**In the Matter of Xcel Energy's 2023 Integrated
Distribution Plan**

Docket No. E002/M-23-452

INITIAL COMMENTS OF FRESH ENERGY

Figure 1 – System Expansion/Upgrades for Reliability/Power Quality¹⁷
(\$ in millions)

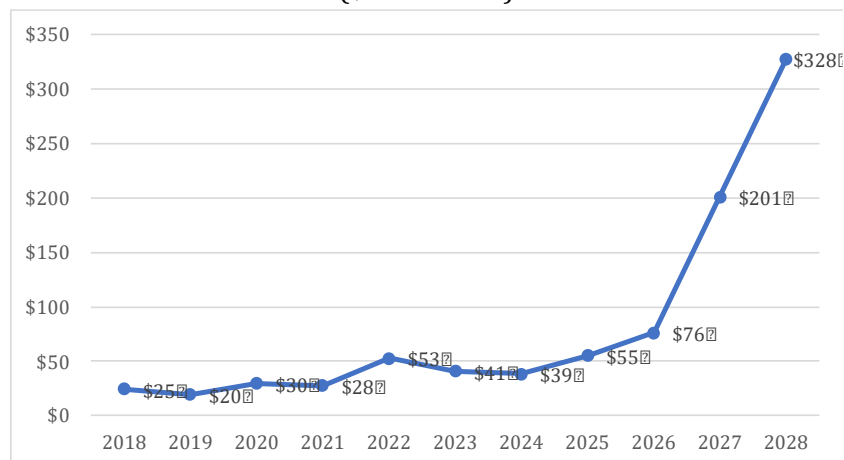
Xcel’s planned **System Expansion or Upgrades for Reliability and Power Quality** expenditures (also contained within the AH&R category in Xcel’s capital budgeting process) are also significantly increasing in the later years of the IDP, as shown in Figure 1 below.

As we explained in Xcel’s most recent rate case proceeding,¹⁹ Fresh Energy believes that a meaningful share of AH&R projects are discretionary, meaning that Xcel has flexibility to determine when, where, and how much to spend. The primary benefit of discretionary AH&R expenditures is improved reliability and resiliency, which Xcel can and has quantified for components of its AGIS initiative. As further explained in our comments responding to Notice Topic 19, Fresh Energy requests that, in its Reply Comments, Xcel confirm that it will work with stakeholders in 2024 to develop a cost-benefit analysis methodology for six categories of discretionary AH&R expenditures (totaling \$1.26 billion from 2024-2028) to demonstrate that customer benefits exceed customer costs.

Figure 2 – Corporate Demand Growth Forecast⁷¹

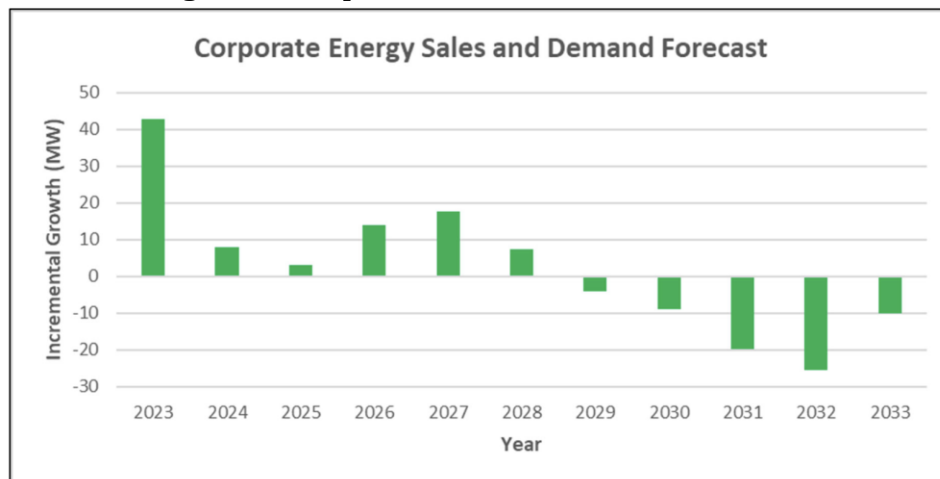
While Xcel's 2023 IDP provides this overview of DSM impacts on the corporate demand forecast, it states that the action plan for DSM "will be largely determined through a combination of the Minnesota Energy Conservation and Optimization (ECO) Triennial (both current and future) filings and the next Integrated Resource Plan (IRP), which is due February 1, 2024."⁷² In response to a

Fresh Energy information request, Xcel acknowledges that, due to timing issues, Xcel's 2023 IDP does not reflect the Company's most recent ECO Triennial plan,⁷³ and therefore likely underestimates the impacts of DSM programs in the 2024-2026 period.
